Work Order ID 165075

ENGINEERING CHANGE NOTICE NO.

DWG NO. 646.9700

DWG TITLE: CUTTER SUB ASSY

SHEET 7, ZONE C3 IS:

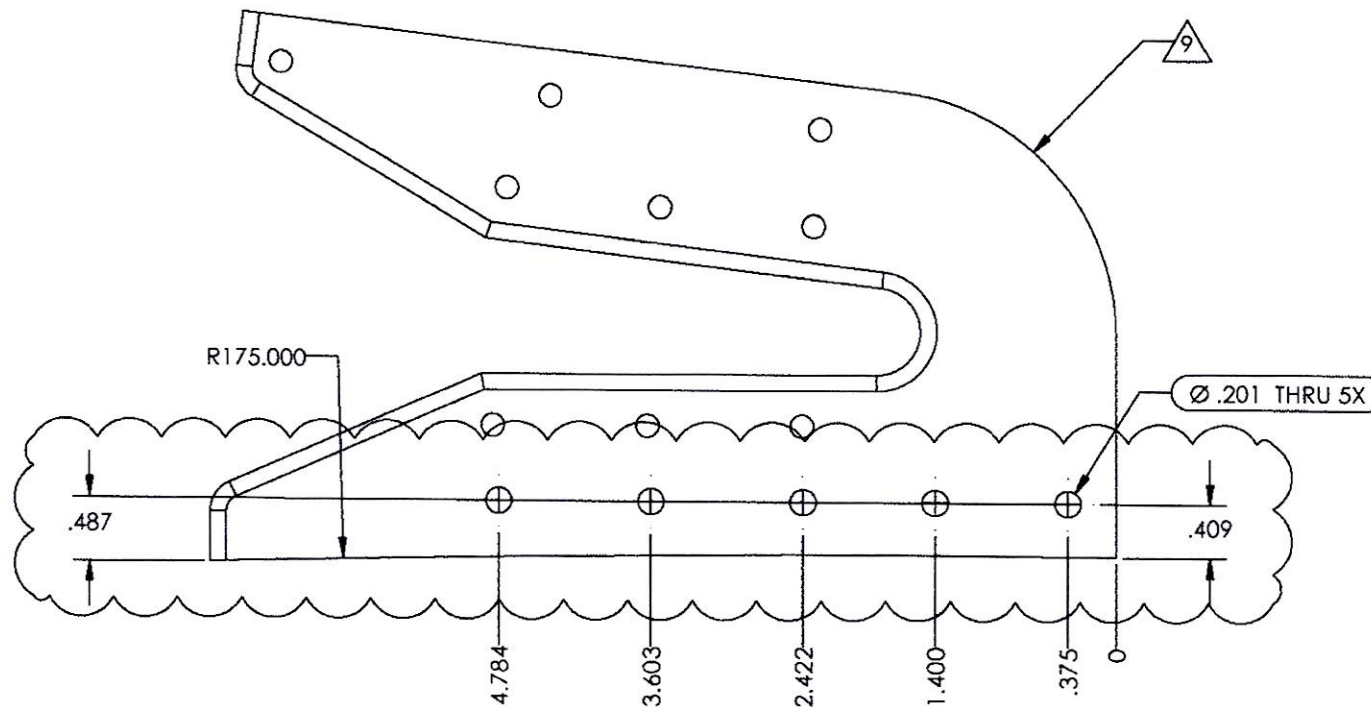
REASON: REVISED DIMENSIONS

ACTION ITEM:
1.

SHEET 1, ZONE A6 IS:

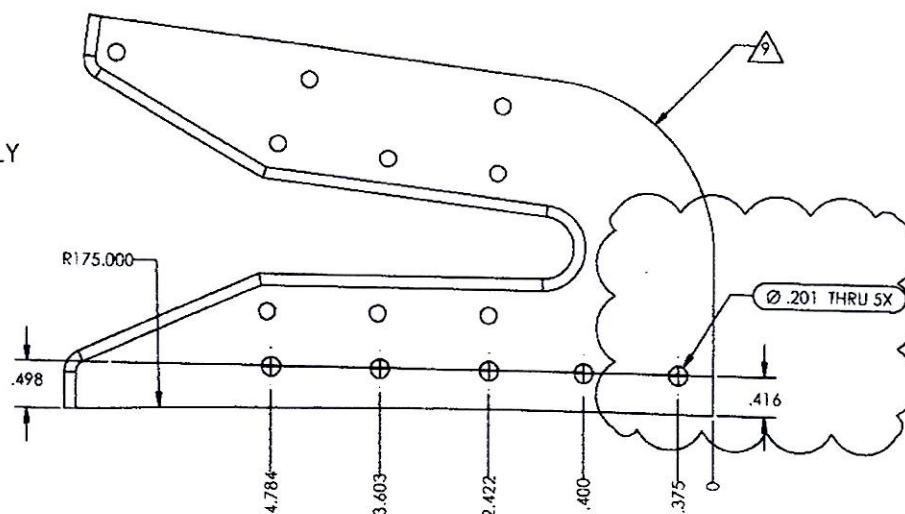
REASON: REVISED NOTES

ACTION ITEM:

IS

- 1 MATERIAL: ALUMINUM 7075-T651 PER AMS-QQ-A-250/12
- 2 FINISH IAW MPP-172 SECTION 2.1, 3.3 & 4.3.
- 3 MATERIAL: AISI A2 TOOL STEEL
CONDITION: ANNEALED
POST PROCESS: HEAT TREAT TO 58-62 Rc ROCKWELL HARDNESS
- 4 FINISH: PRIME IAW MPP-172 SECTION 3.3; 1-2 MIL MAX
5. DEBURR AND BREAK ALL SHARP EDGES EXCEPT WHERE OTHERWISE NOTED
6. IDENTIFY IAW MPP-120
- 7 APPLY F/N 5 AS REQUIRED TO ALL FAYING SURFACES OF F/N 2 UPON ASSEMBLY
- 8 CUTTING EDGE INTENDED TO BE SHARP, DO NOT BREAK SHARP EDGE
- 9 ALL DIMENSIONS NOT SPECIFIED ARE CONTROLLED BY 646.9710.
